**Micro Bird Inc**

**SAFETY  
RECALL**

**TITLE:** Flat floor (torn wire insulation)

**Reference:** Recall 11-044-EHU /NHTSA #11V-319

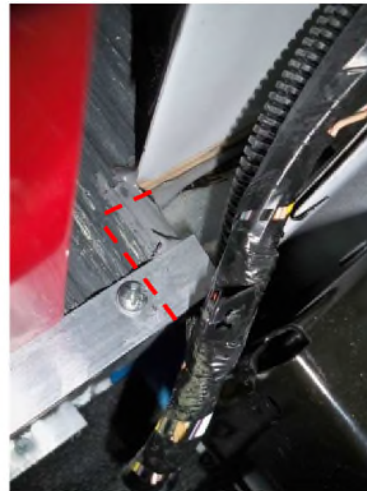
This document contains procedures to modify the floor behind the driver on Ford buses G5 flat floor model.

- 1- Push the driver's seat to the farthest position near the dash.
- 2- Remove the corner trim and the B Pillar trim.

- 3- Remove the aluminum trim and cut approximately one inch at the end.
- 4- Remove the same area on the corner of the floor using a wood chisel to allow clearance of the electrical harness. (The use of any saw is not recommended since there is a metal sheet under the plywood.)

- 5- Install a loom or any other protection against abrasion over the OEM harness. An electrical tape is not sufficient.
- 6- **Fix the harness in place using sealant (very important).**
- 7- Reinstall the aluminum trim.
